Subject: AP1000 Response to Request for Additional Information (SRP 23)

AP1000 TECHNICAL REPORT REVIEW

RAI Response Number: RAI-DCP-CN55-SBP-01
Revision: 0

Figure 1 Refueling Cavity Seismic Category Valve and Lines

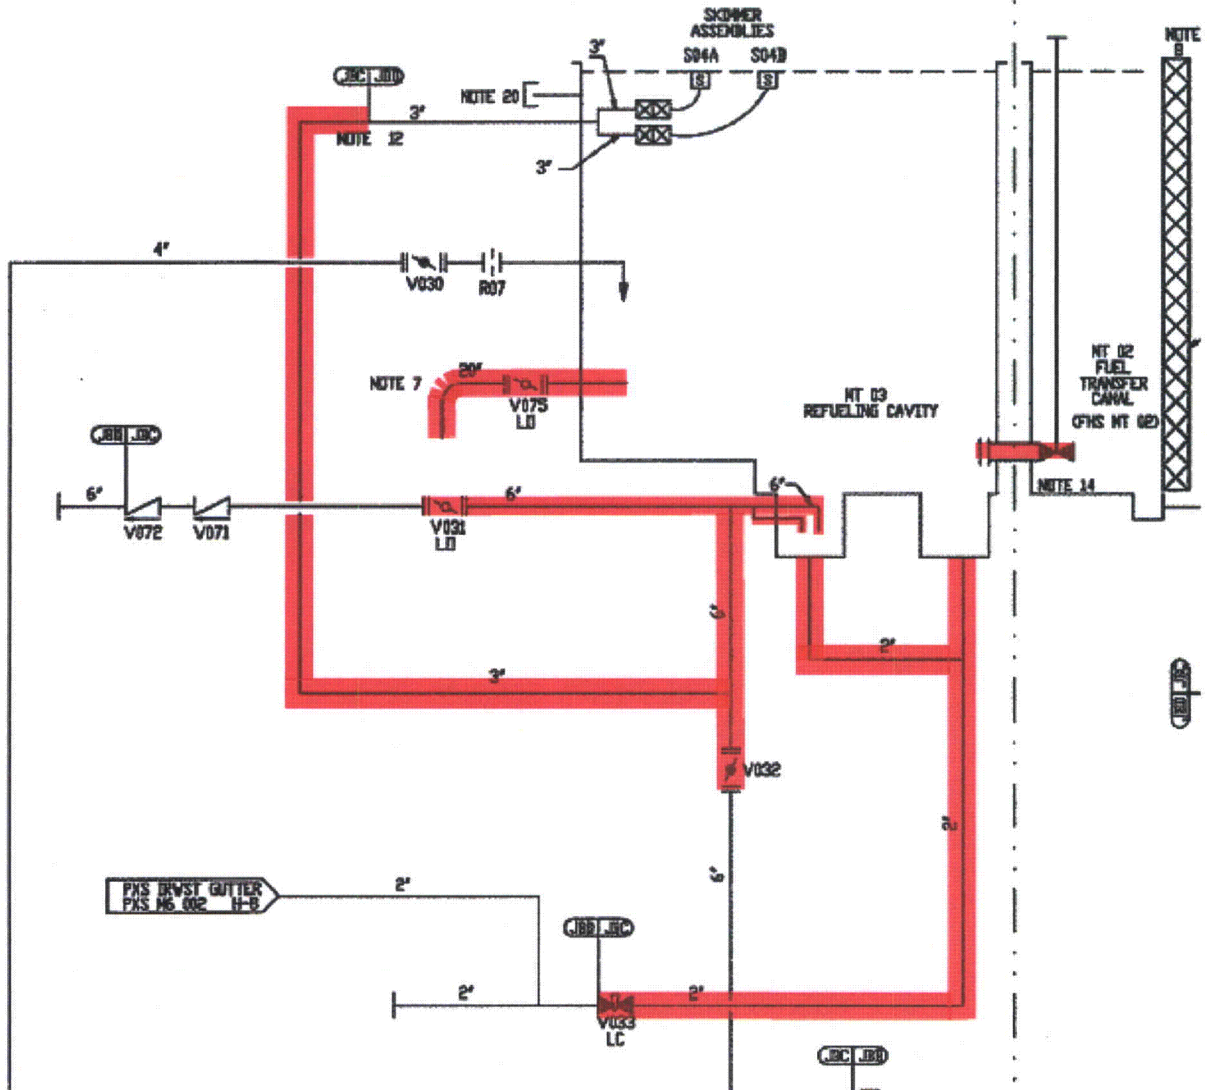
- e. Tier 2 Figure 9.1-6 (Sheet 1 of 2) "Spent Fuel Pool Cooling System Piping and Instrumentation Diagram," shows additional possible refueling cavity drain paths (for example, the piping segment between the refueling cavity and valve V030 and the piping segment between the refueling cavity and valve V032). Additional information is needed to explain how the integrity of the refueling cavity is ensured during refueling operations for all other penetrations that exist, including confirmation that these penetrations and associated isolation valves are seismic Category 1. The applicant is also requested to confirm that all refueling cavity drain path isolation boundary piping and components are described in Tier 2 and included in the appropriate Tier 1 sections and tables.

- e. The spent fuel pool and refueling cavity are designed to limit exposure rates to personnel on the refueling machine to 2.5 millirem per hour per Tier 2 Section 9.1.3.1.5. All refueling cavity penetrations and associated isolation valves that are at elevations below the minimum safety level outlined in Tier 2, Chapter 16 Tech Spec 3.9.4 are designed as Seismic Category I, and will not fail during a design basis accident.

The Seismic Category I Valves and Lines are listed below and outlined in Figure 1, which is a portion of Tier 2, Figure 9.1-6.

Seismic Category I Valves: V075, V031, V032, V033, Fuel Transfer Tube Isolation Valve

Seismic Category I Piping: L030, L033, L036, L037, L044, L120, L121, Fuel Transfer Tube

Figure 2.3.7-1
Spent Fuel Pool Cooling System

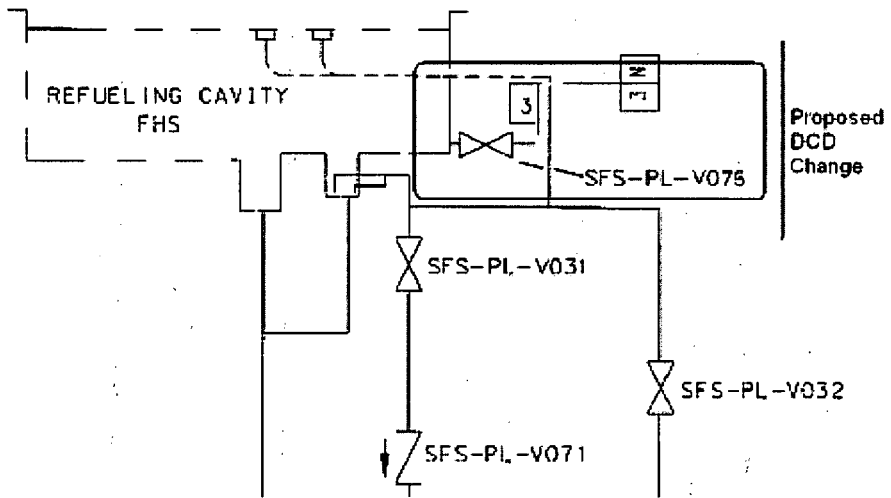
- c. The staff verified that the functional diagram presented in Tier 1 Figure 2.3.7-1 does not show V075. Since valve V075 is needed during refueling to maintain the integrity of the refueling cavity and the spent fuel pool, the applicant is requested to update the functional diagram to include valve V075 and the associated piping segment.

- c. The drawing will be revised to include SFS-PL-V075 per the attached mark-up.
- d. The valve configuration descriptions provided in Tier 2 Section 9.1.3.3.5 is still valid and has not been impacted by the proposed change.

(See revised Figure 2.3.7-1, attached)
